RESOLUTION: To approve, with conditions, Project Plan Application No. PJT2009-00001, Kol Shalom

Re: Kol Shalom
Stormwater Management (SWM) Concept
PAM2009-00001/SMP2009-00009

SUBJECT: Transportation Staff Report
Kol Shalom, 9104, 9110 and 9150 Darnestown Road, PJT2009-00001

Re: Kol Shalom
Project Plan #PJT2009-00001

Exhibit A

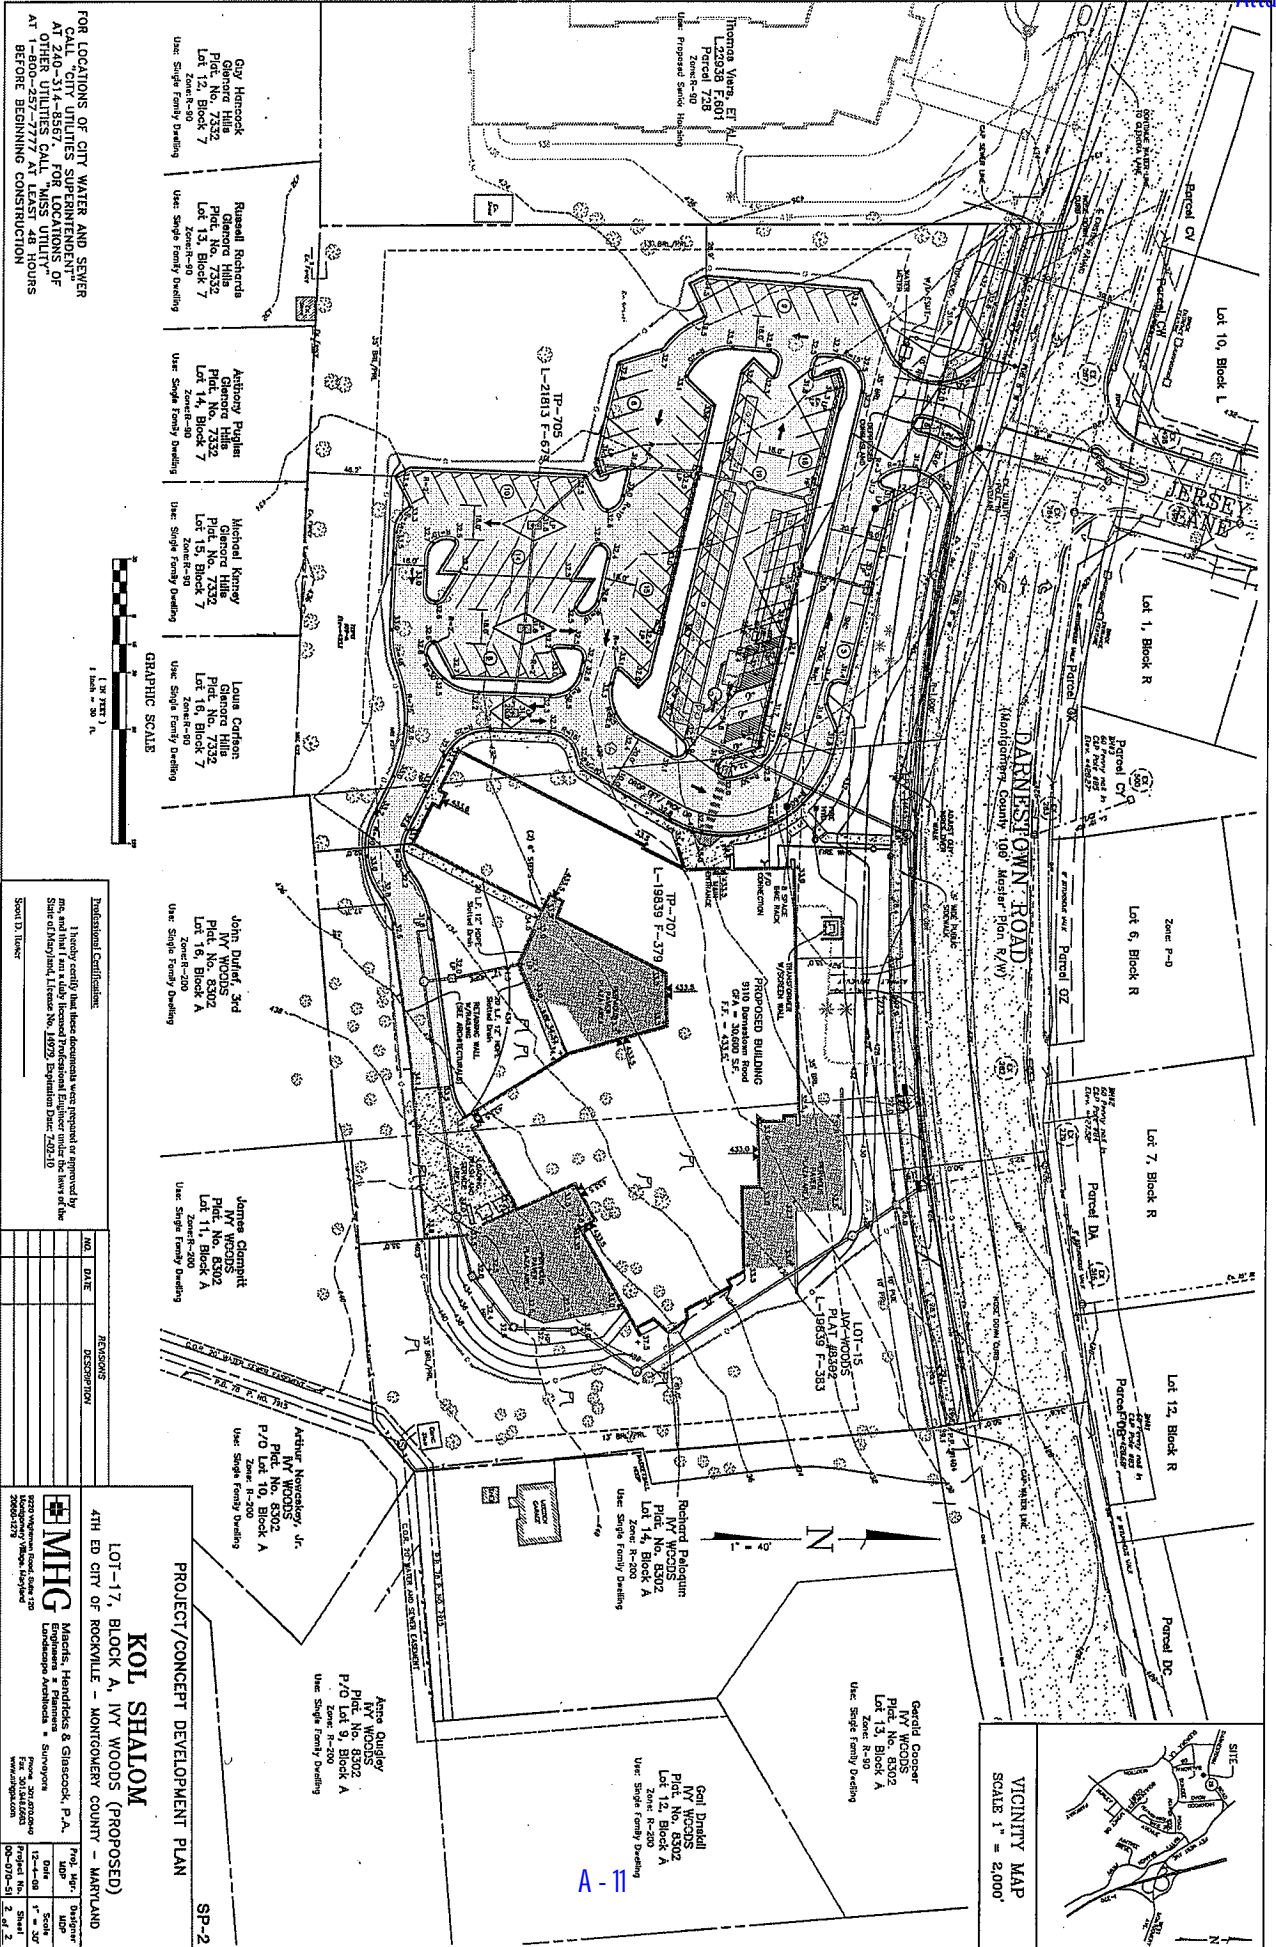
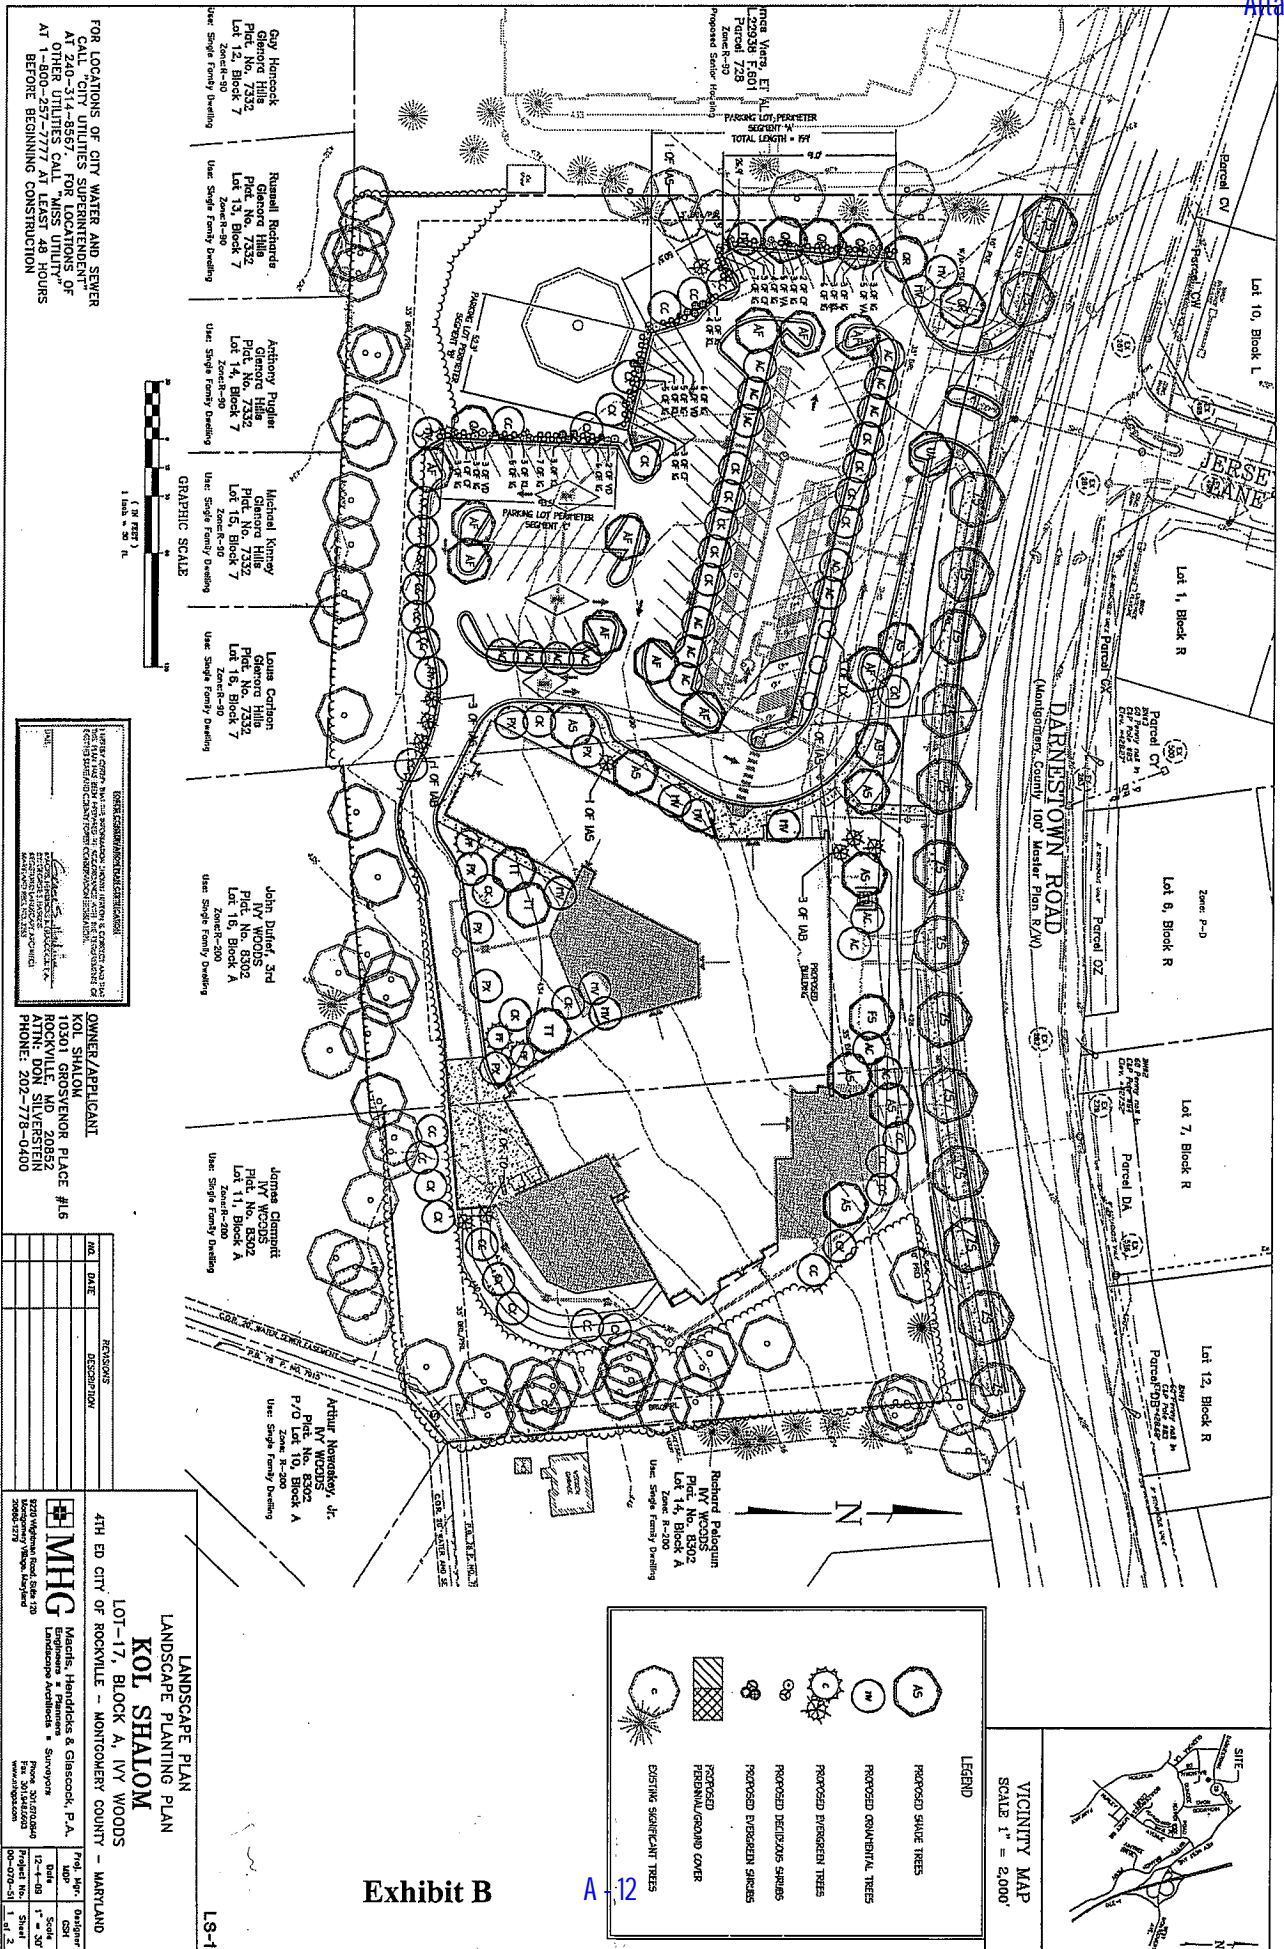
The subject property shall be developed in accordance with the Project Plan/Concept Development Plan dated December 4, 2009, attached hereto and incorporated herein as Exhibit "A". To the extent that there is a conflict between any of the written items and conditions in the body of this Resolution and any exhibits attached hereto, the written terms and conditions in the body of this Resolution shall control.

- (a) Maximum height: 40 feet
- (b) Minimum setbacks: A minimum 35 foot front yard setback, a minimum 13 foot side yard setback and a minimum 35 foot rear yard setback.
- (c) Impervious surface: No more than 20 percent of the front yard may be impervious surface.

Exhibit B

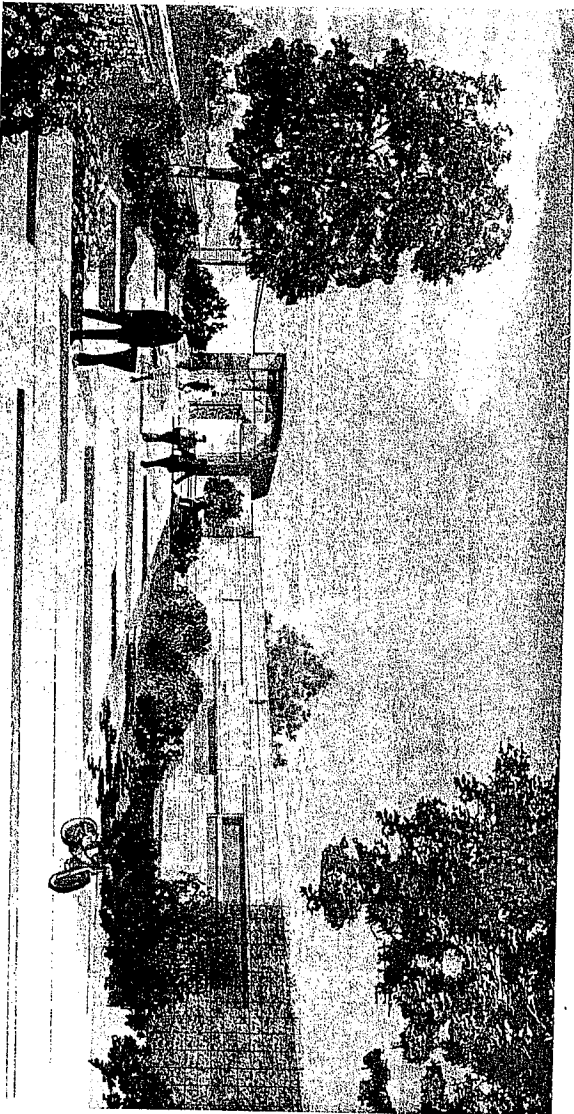
3. LANDSCAPE PLAN: The Applicant must submit a detailed landscape plan for approval by the Planning Commission at the Level 2 Site Plan stage. The landscape plan must be generally consistent with the conceptual landscape plan attached hereto as Exhibit "B" (the "Conceptual Landscape Plan").
